EXPANDORAM™

EXPANDABLE RAM Printed Circuit Board

SD Systems

EXPANDORAM REVISION NOTICE

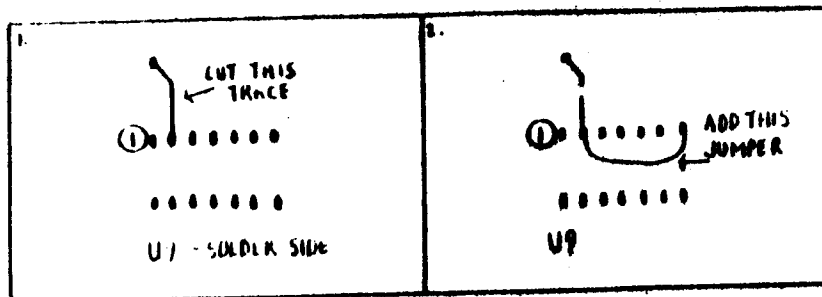
If you are using your Expandoram in a disc based system, with the SD SBC-100, or in a system that generates asynchronous wait states, the following modification should be made. This modification, when performed on systems utilizing a front panel, will cause loss of the DEPOSIT function.

1. Cut PC trace from U4 pin 8 to U9 pin 2.
2. Add wire jumper from pin 2 U9 to pin 7 of U9.
